LEAD LOCAL FLOOD AUTHORITY, OXFORDSHIRE COUNTY COUNCIL PROOF OF EVIDENCE

Proof of Evidence to the Planning Inspectorate on behalf of the Lead Local Flood Authority (LLFA) concerning the planning appeal Appeal by Great Lakes UK Limited against Cherwell District Council's refusal to grant planning permission for the Redevelopment of part of golf course to provide new leisure resort (sui generis) incorporating waterpark, family entertainment centre, hotel, conferencing facilities and restaurants with associated access, parking and landscaping at Land to the east of M40 and south of A4095 Chesterton Bicester Oxon

PINS reference: APP/C3105/W/20/3259189

Dealing with matters relating to FLOOD RISK & SUSTAINABLE DRAINAGE (Refusal Reason 5)

Figure 1 – Schematic from Curtins FRA (Application boundary shown in red)

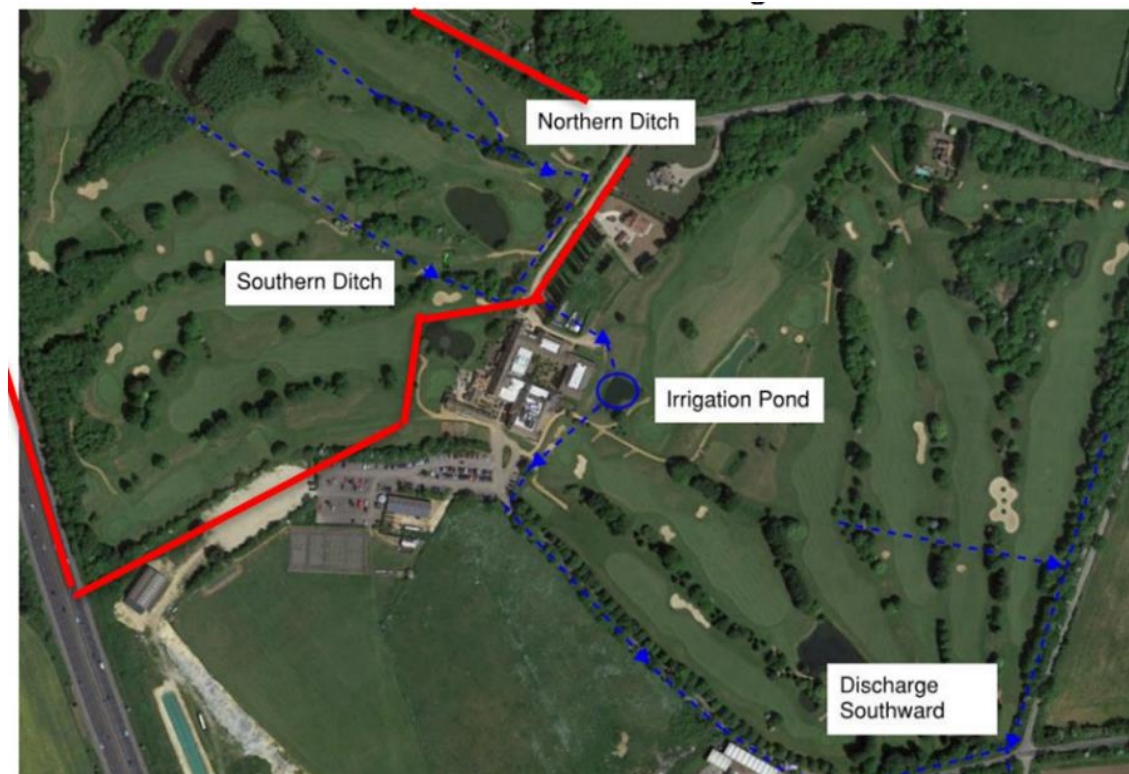
- 5.3. The ditches shown in the red line boundary on the plan in Figure 1 above are proposed to be removed. As well as these ditches, there is an online pond that is proposed to be removed on the northern ditch and two ponds to be removed adjacent to the southern ditch. A further larger pond is also proposed to be removed. The removed features are shown in Figure 4 in Section 7.

Figure 3 – UAV Groundwater Survey from Curtins FRA for the proposed development (Application boundary shown in red)

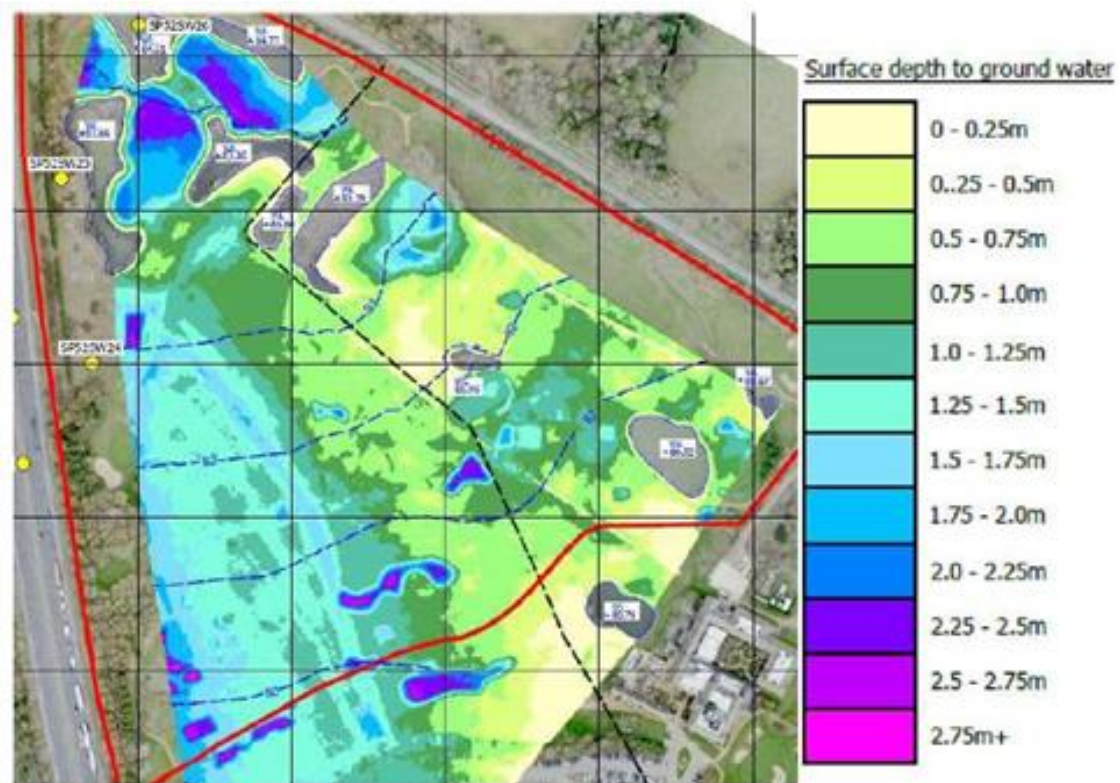
3.5. The change in geology coincides with the UAV groundwater survey provided in the Curtins FRA and Drainage Strategy for the proposed development which demonstrated groundwater was within 0-0.5m of ground level within the proposed site boundary.

7.2.1. Groundwater is between 0-0.5m below ground level in places, especially where the tank is proposed. That is why the existing features are shallow to manage surface water above the groundwater which is in line with best practice. However, the proposed solution is proposing to manage surface water significantly lower with the proposed tank being below and completely submerged in groundwater.

Figure 4 - Existing ponds (in red) and ditches (in blue) to be removed. Plan from the Curtins FRA for the proposed development

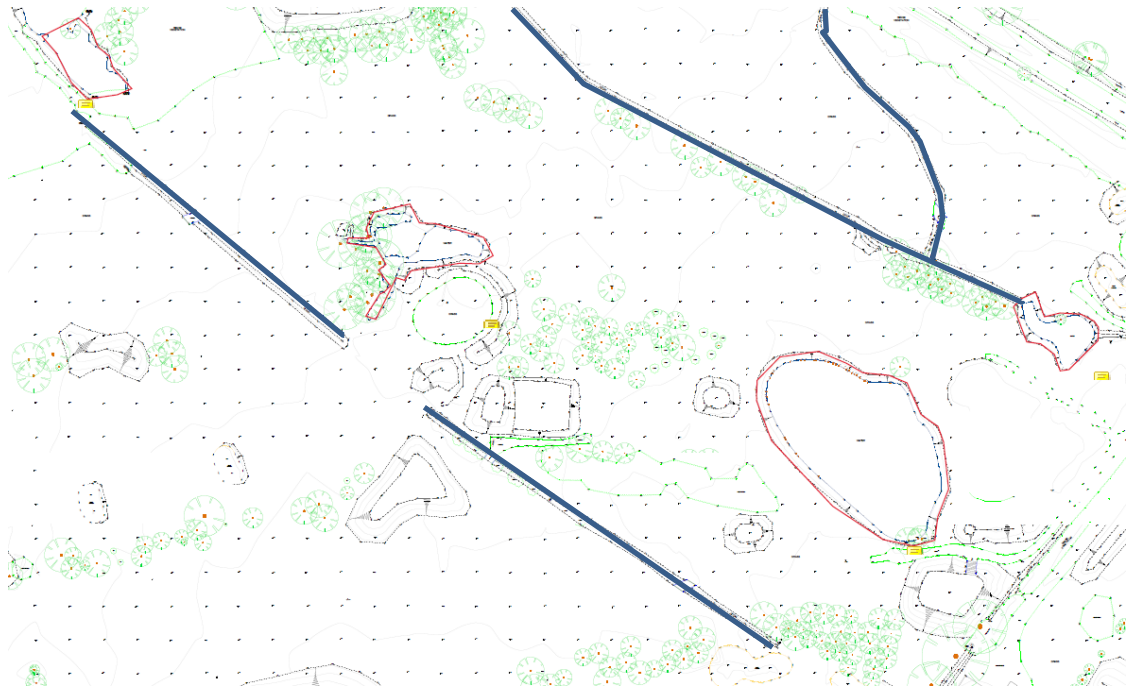
7.2.3. There are three ponds to be removed and part of a further pond on the northern boundary is also shown to be removed. The largest pond is 2600m² in area with approximately 400mm of free depth recorded from the water level and lowest bank level on the topographical survey. The depth is unknown, but the water level currently takes up approximately 2000m² in area which will fluctuate with groundwater levels. There is a significant volume of water in this pond that will be lost post development. There is also a significant area of groundwater storage which will be lost by the introduction of the tank. This loss of groundwater storage has not been compensated for in the strategy.

- 7.7.1. We have never approved the proposed replacement/realignment of the ditches as the applicant's consultant claims in the planning responses from Curtins, most recently in their response letter of 11th December 2020 which is included in Appendix C. The proposed ditches are not being reinstated appropriately. The existing ditches are on average 3-4m wide and 0.3-1m deep. The proposal has squeezed 1m wide ditches in the proposed layout which are culverted in many places. This is not an acceptable replacement. We have repeatedly stated in our responses included in Appendix C and during meetings that the existing drainage features must be retained. All ditches, no matter when installed are classed as ordinary watercourses.

- 7.7.3. The ditches, which are classed as ordinary watercourses, and ponds proposed to be removed are located in the area where ground water levels are recorded to be at their highest on the site. These are shown in Figure 4 below.

Figure 5 – Outfall schematic from Curtins FRA for the proposed development with existing and proposed levels shown (Application boundary shown in red)

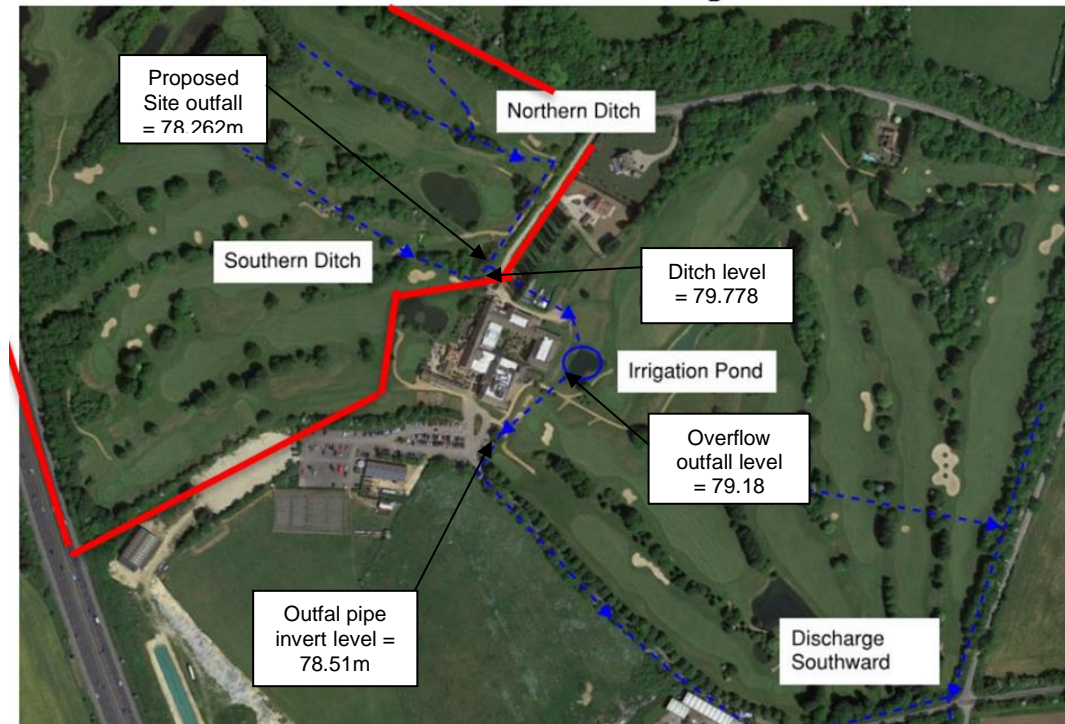
7.8.2. The irrigation pond and outfall levels are provided in the drainage strategy for the discharge of condition application 17/00037/DISC for the 62-bed extension to existing Bicester Hotel. These levels are overlaid on the schematic from the Curtins FRA below. The original 2017 strategy is included in appendix D.

7.8.3. The outfall level from the irrigation pond is higher than the proposed level for the drainage scheme which is 130m downstream. Therefore, the proposed drainage scheme at the assumed level will need to flow uphill, and therefore does not work hydraulically as claimed in the Drainage Strategy.
